**COAL ASH IMPOUNDMENT  
SITE ASSESSMENT DRAFT REPORT**

**Marion Power Station  
Southern Illinois Power Cooperative  
Marion, Illinois**

**KLEINFELDER PROJECT NUMBER 118953-5**

**March 20, 2012**

Photo 13 – Ash Pond 2 Discharge Pipe into Ash Pond 4  
May 25, 2011 IL50160

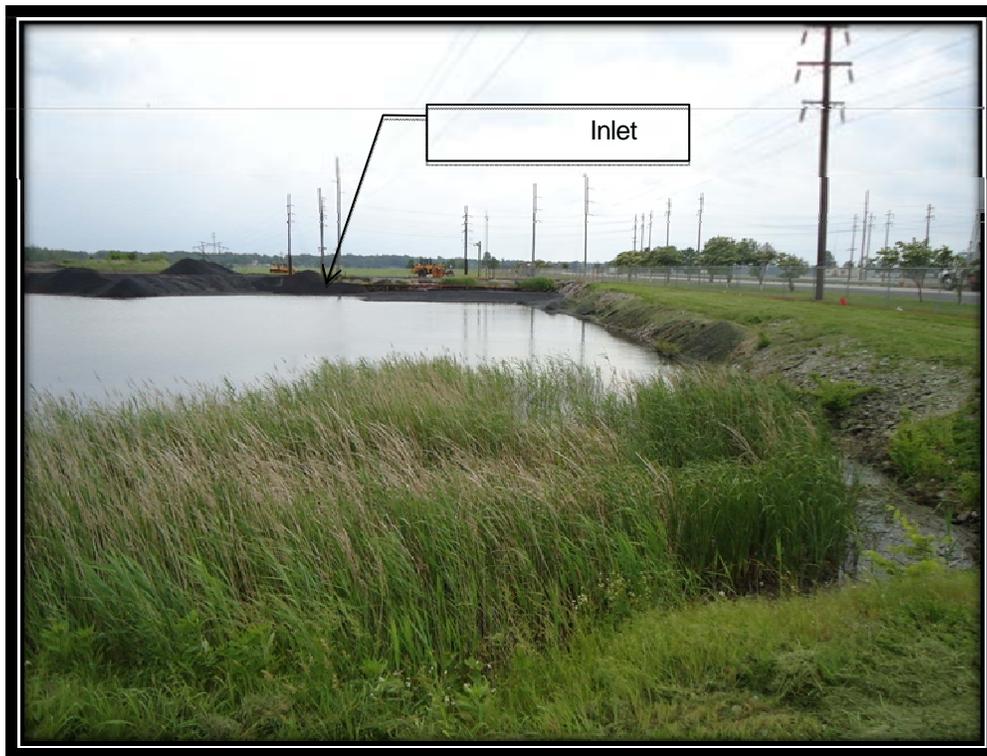
datum, or show a second discharge pipe into Pond 4. These pipes are not controlled by valves or gates and do not utilize trash racks. Photo 16 shows the condition of the outlet pipes. Specific observations include:

TYPICAL EMBANKMENT SECTION - EMBANKMENT SEPARATING ASH POND 1 AND 2

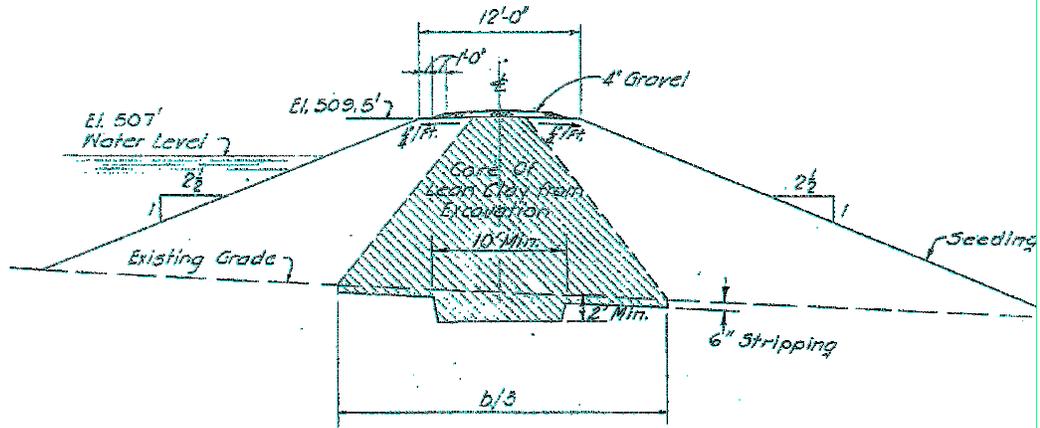
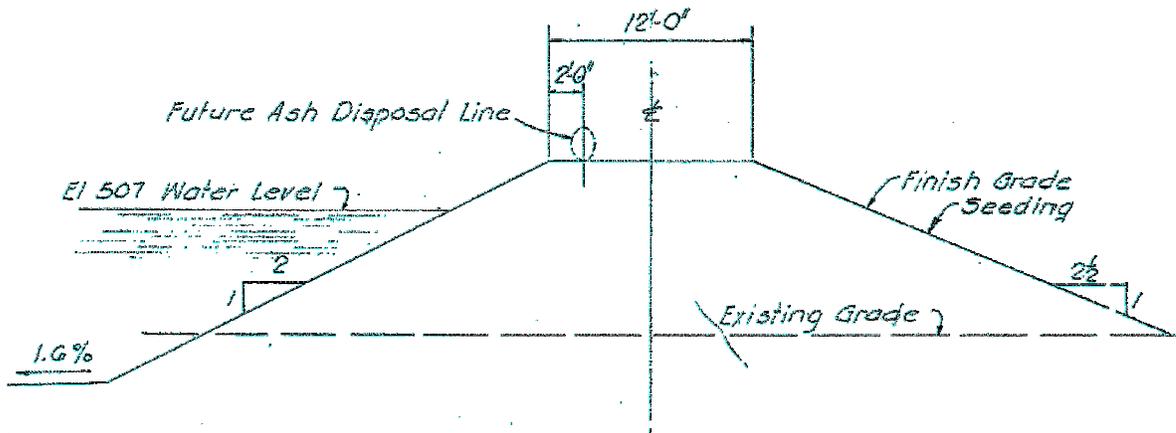
Ponds 1 and 2 are incised impoundments, originally constructed with an earthen embankment that has been filled against to incise the ponds. Figure 3 displays cross sections of Ponds 1 and 2 taken from the supplied as-built drawings. Steel sluice pipes transporting bottom ash from power generating operations outlet at the southeastern corner of both Pond 1 and Pond 2. Once this sluiced material is deposited into either Pond 1 or Pond 2 it is transferred via outlet pipe culverts into Pond 4. The outlet pipes for Pond 1 are located close to the northwest corner of the impoundment with varying inlet elevations. These culverts were noted as being plastic pipes, one 12-inch and one 18-inch pipe, with the 18-inch plastic pipe having a lower intake elevation. The outlet pipe for Pond 2 is located close to the southwest corner of the impoundment. This culvert was noted as being a steel pipe 12-inches in diameter.

**DESCRIBE REASONING FOR HAZARD RATING CHOSEN:**

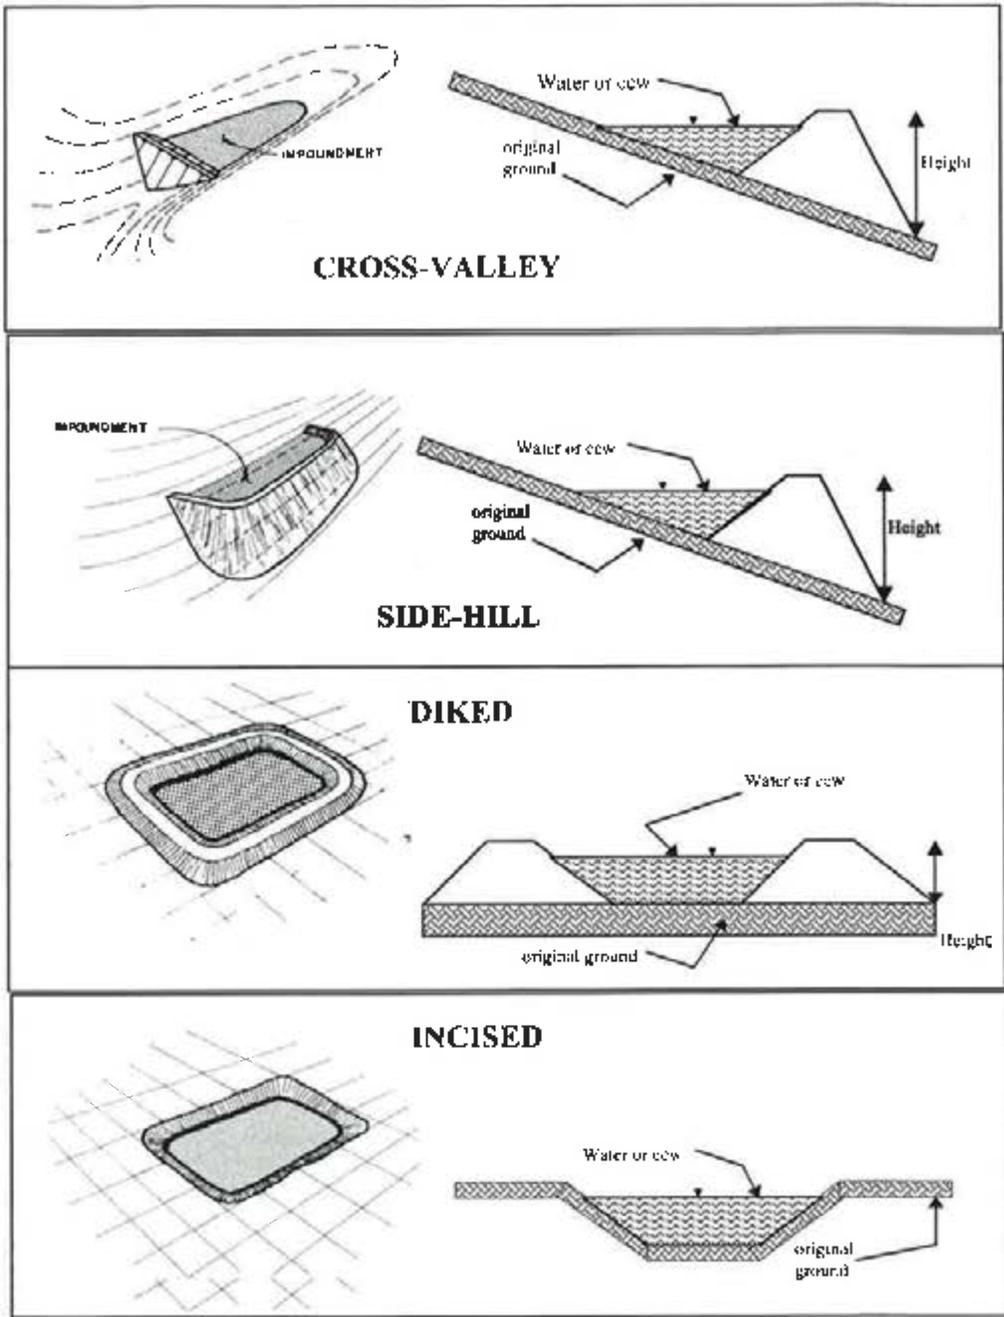
POND IS INCISED AND FAILURE IS NOT A LIKELY PROBABILITY. MISOPERATION  
COULD OVERFILL POND 1&2 WITH SLURRY. THIS WOULD LIKELY RESULT  
IN POND 1&2 OVERTOPPING INTO POND 4 WHICH WOULD THEN HAVE  
TO FILL AND OVERTOP BEFORE ENVIRONMENTAL OR ECONOMIC  
IMPACTS WOULD BE SEEN. THERE ARE NO FACILITIES LOCATED  
ADJACENT THE THE IMPOUNDMENTS THAT WOULD LIKELY DOSE  
A LOSS OF LIFE CIRCUMSTANCE IN THE EVENT OF MISOPERATION/  
FAILURE. DAMAGE IN THE CASE OF MISOPERATION/FAILURE  
WOULD LIKELY BE CONTAINED TO THE OWNERS PROPERTY.  
IT IS OUR UNDERSTANDING THAT THE IMPOUNDMENTS WERE NOT  
CONSTRUCTED OVER WET ASH, SLAG OR OTHER UNSUITABLE  
MATERIALS SIMILAR TO THE KINGSTON TVA SITE.

**DESCRIBE REASONING FOR HAZARD RATING CHOSEN:**

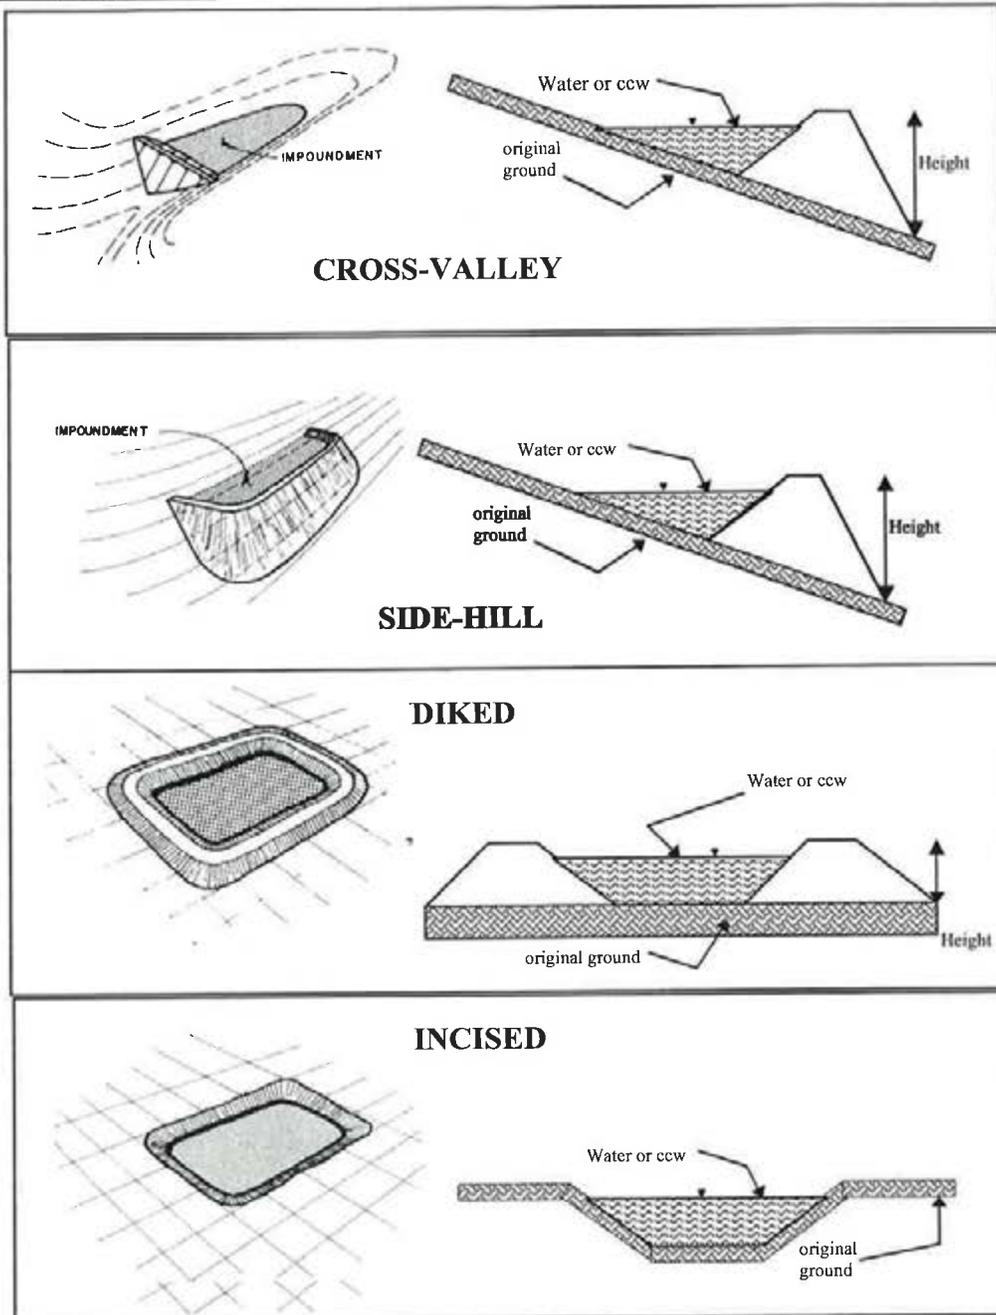
POND IS INCISED AND FAILURE IS NOT A LIKELY PROBABILITY. MISOPERATION  
COULD OVERFILL PONDS 1+2 WITH SLURRY. THIS WOULD LIKELY RESULT  
IN PONDS 1 + 2 OVERTOPPING INTO POND 4 (WHICH WOULD THEN)  
HAVE TO FILL AND OVERTOP BEFORE ENVIRONMENTAL OR  
ECONOMIC IMPACTS WOULD BE SEEN. THERE ARE NO FACILITIES  
LOCATED ADJACENT TO THE IMPOUNDMENTS THAT WOULD LIKELY  
POSE A LOSS OF LIFE CIRCUMSTANCES IN THE EVENT OF  
MISOPERATION/FAILURE. DAMAGE IN THE CASE OF MISOPERATION/  
FAILURE WOULD LIKELY BE CONTAINED ON THE OWNERS PROPERTY.  
IT IS OUR UNDERSTANDING THAT THE IMPOUNDMENTS WERE NOT CONSTRUCTED  
OVER WET ASH, SLABS OR OTHER UNSUITABLE MATERIALS SIMILAR TO  
THE KINGSTON TVA SITE.
